CITY OF MISSOURI CITY
PLANNING AND ZONING COMMISSION AGENDA

PLANNING AND ZONING COMMISSION
STAFF REPORT

AGENDA DATE:	March 09, 2016
AGENDA ITEM SUBJECT:	Final Plat of Avalon at Sienna Plantation Section 2
AGENDA ITEM NUMBER:	6.A.(1)
PROJECT PLANNER:	Jose Abraham, Planner I
APPROVAL:	**Kelly Carpenter**, AICP, Development Services JGG for KC **Jennifer Thomas Gomez**, AICP, Interim Assistant Director, Development Services JGG **Katherine Ostroff,** Public Works JGG for KO

FINAL PLAT OF
AVALON AT SIENNA PLANTATION SECTION 2

FINAL PLAT OF
AVALON AT SIENNA PLANTATION SECTION 2

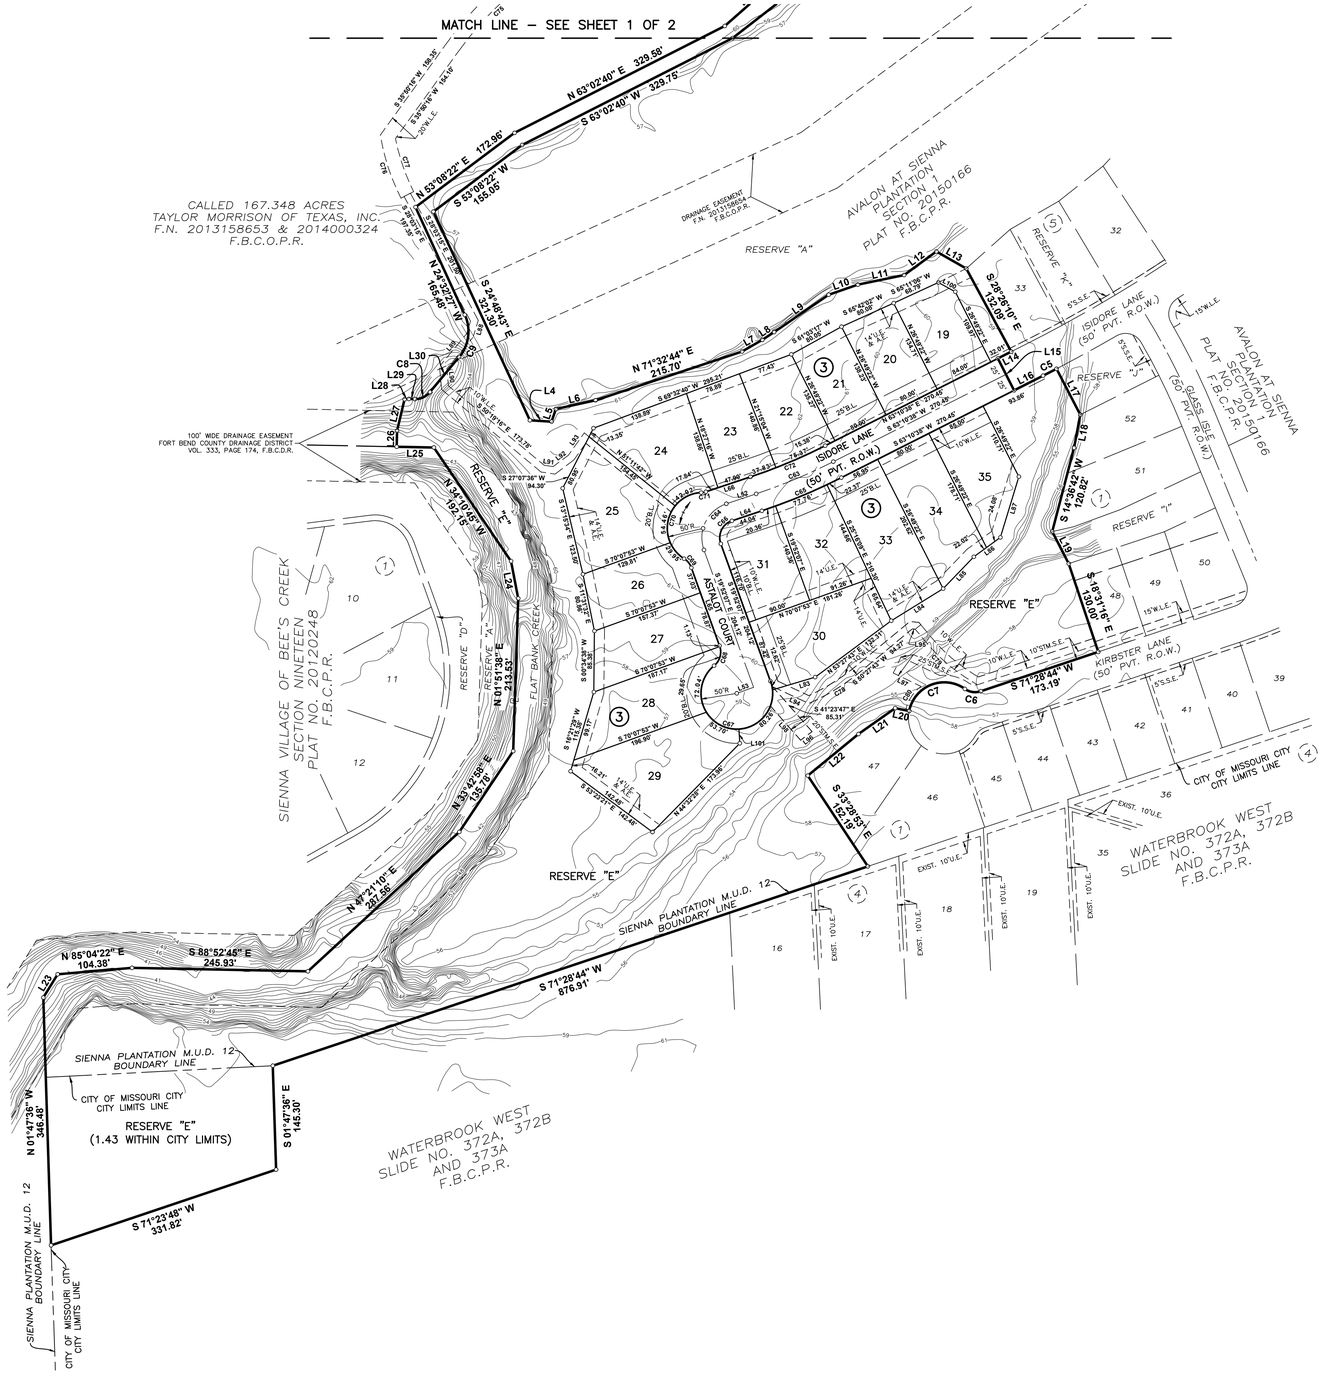
d. Revise owner's acknowledgement and the Planning and Zoning Commission's certificate to correctly reference the proposed subdivision.

e. The street name "Astalot Court" is spelled differently on the plat and the list of street names. Please revise to be consistent.

c. Easement locations and widths are subject to further review dependent on review of the construction plans for the site.

d. Please provide slab elevation to be included in Note 12.

a. Revise plat note #14 to read as follows: "All drainage and floodway easements shall be kept clear of fences, buildings, plantings and other obstructions to the operations and maintenance of the drainage facility as required by Subsection 82-168(d) of the Code of Ordinances of the City of Missouri City, Texas."

LANDSCAPE PLAN

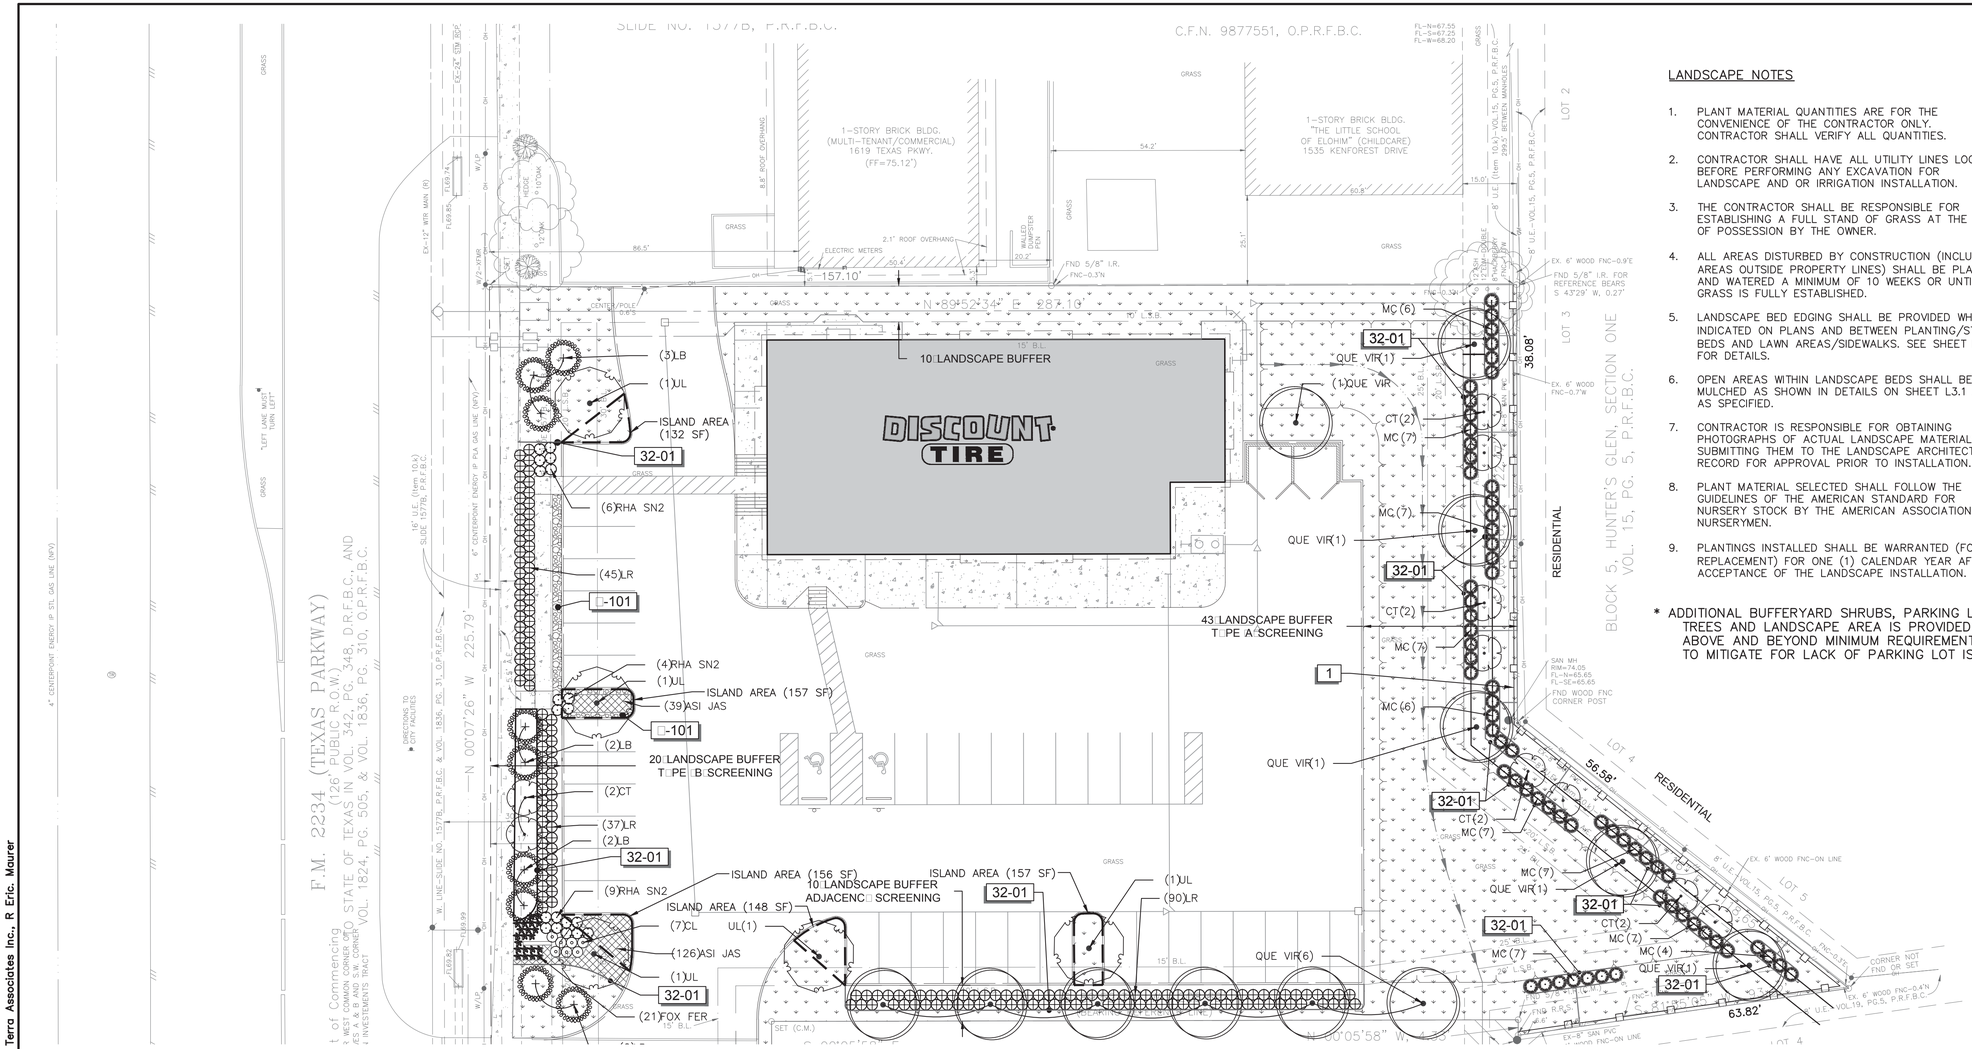
The applicant has submitted a landscape plan for the proposed development. Generally, the proposed development is consistent with the requirements of the City's landscaping regulations.

The plan provides for transitional buffer yards along Texas Parkway as well as where the subject site is adjacent to a single family residential development. The plan depicts associated landscaping as required within these buffer yards. Landscaping required to screen off-street parking areas has been provided for in addition to interior landscape requirements to reduce the amount of impervious surfaces within the development.

Additionally, the applicant is seeking to reduce the number of planting islands or diamonds which would be required in the parking lot due to the nature of the store's operation and the flow of vehicles entering and exiting the building. The applicant proposes to increase the buffer yard along the common line of the subject site and a single family residential district to offset the lack of planting islands and diamonds. The buffer yard is proposed to be a minimum of 43-feet in width. A detention facility is proposed to be located within this area along with landscaping as required.

Staff Recommendation: Allow for the provision of an 8-foot tall, wood fence along the length of the buffer yard adjacent to the single family residential subdivision and require a minimum buffer yard depth of 43 feet in this area. Allow for a decrease in planting islands and diamonds to the areas shown on the conceptual site plan provided that enhanced landscaping is provided within the transitional buffer yards and other areas of the site as shown on the plan. The applicant and/or developer should work with the residential property owners immediately adjacent to the subject site to ensure that new fencing is provided in coordination with any existing fencing and prevent the creation of an unmaintained area between any fencing.
